Project T10/1760-D

Revision 14
28 January 2008

Information technology - Serial Attached SCSI - 2 (SAS-2)

Summary of Comments on Serial Attached SCSI - 2 (SAS-2) Standard

Figure 155 — SP (phy layer) state machine - SAS speed negotiation states

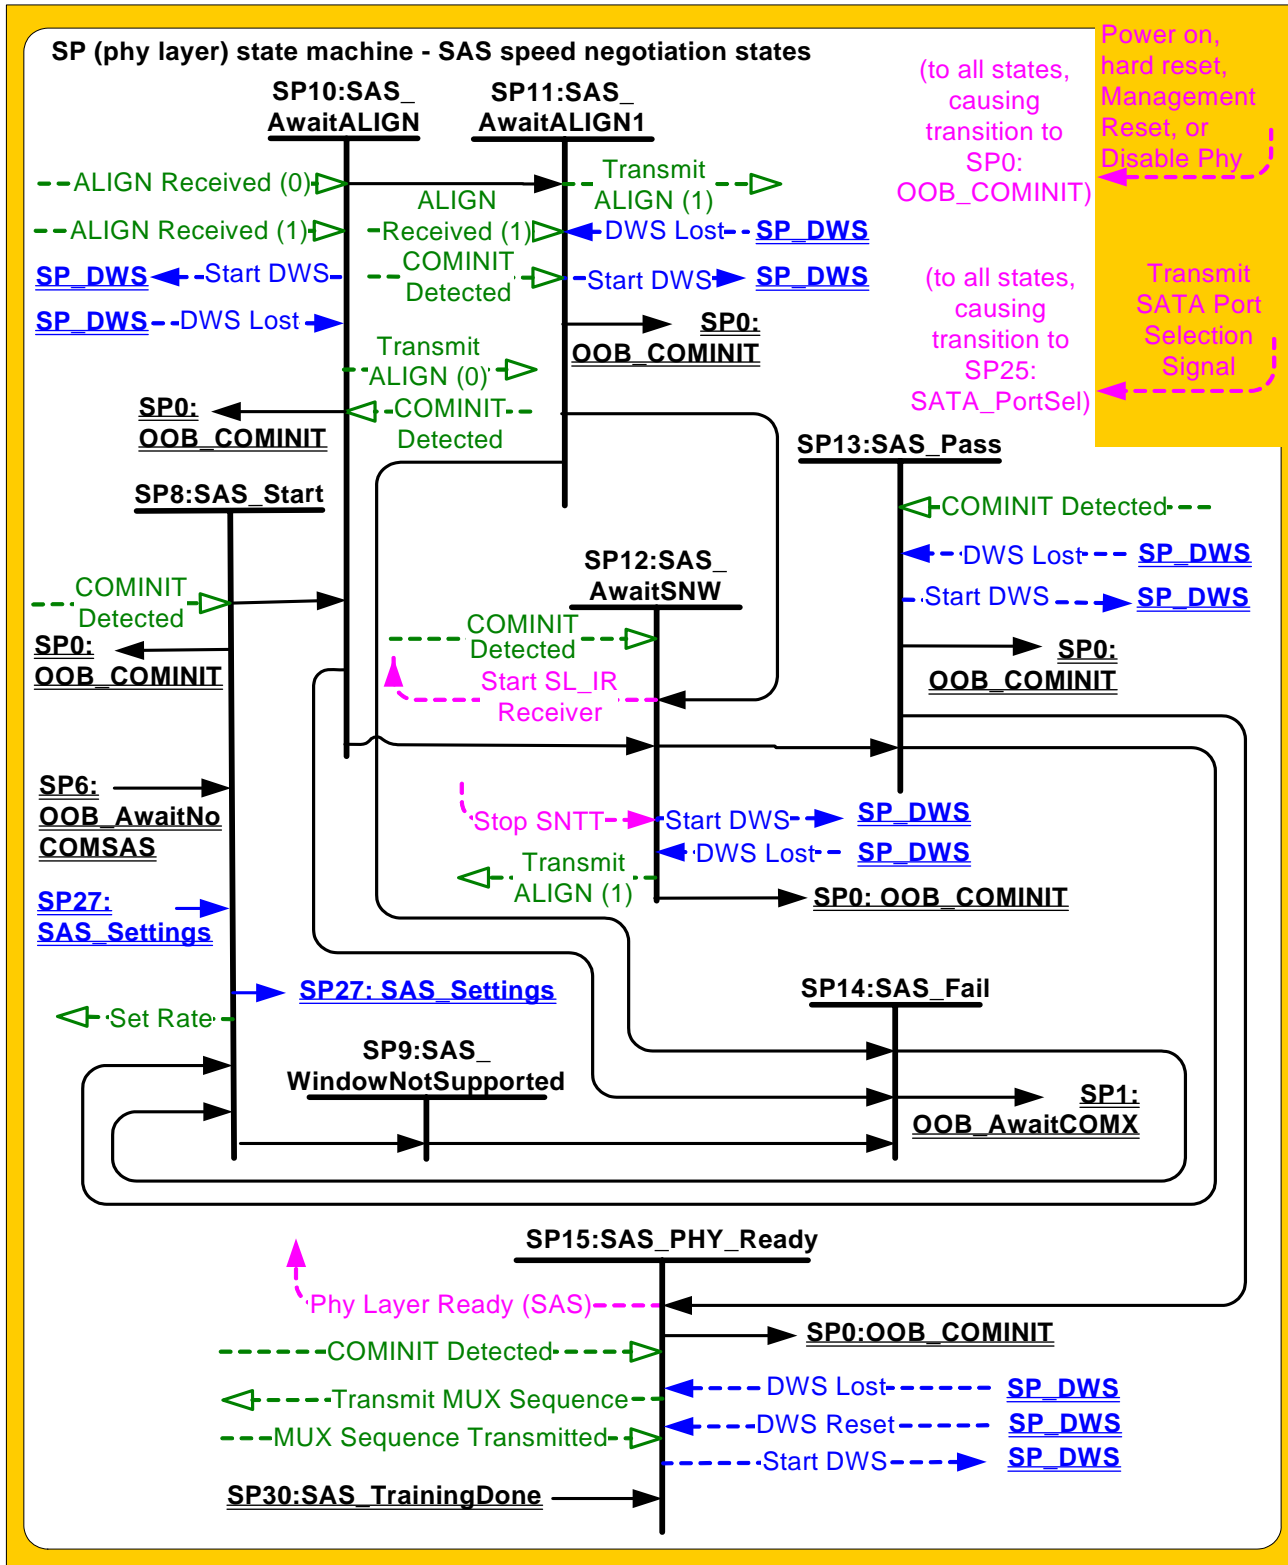
● Author: wdc-mevans
Subject: Highlight
Date: 3/28/2008 10:22:45 AM
T and performs
s/b
and the states in the state machine perform

Figure 157 — SP (phy layer) state machine - SATA host emulation states

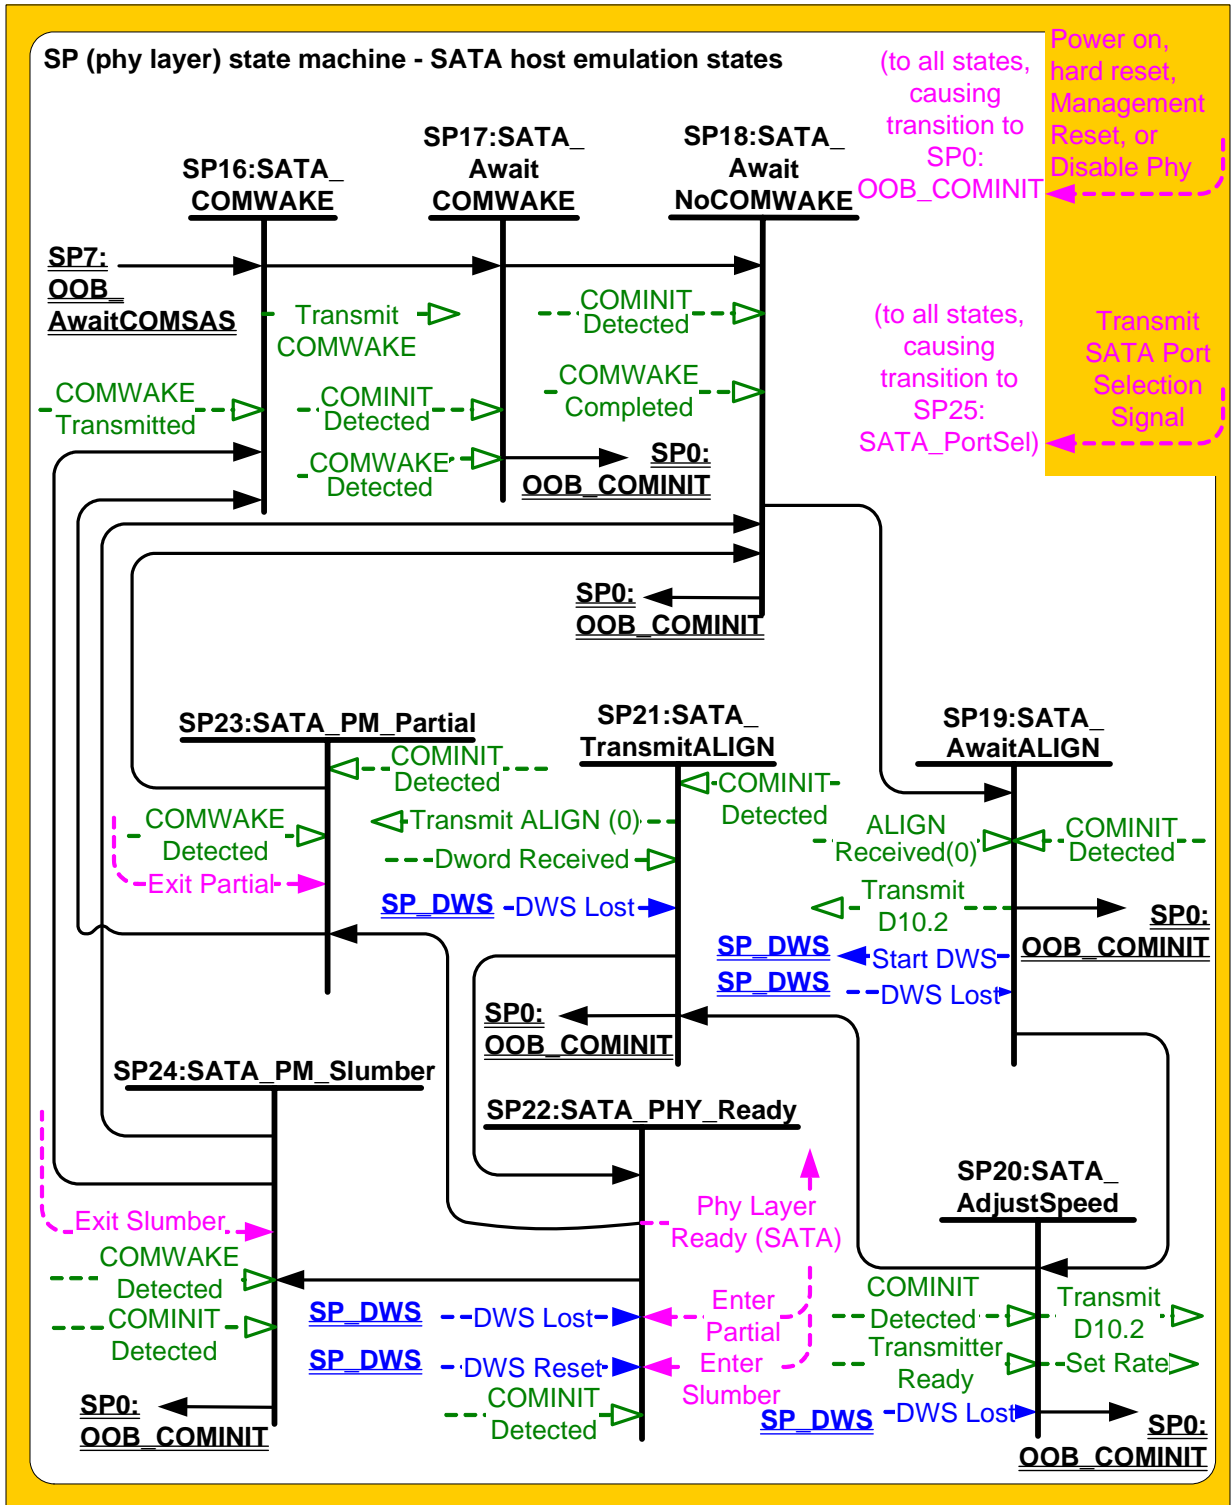
T SATA; expander
s/b
SATA. Expander
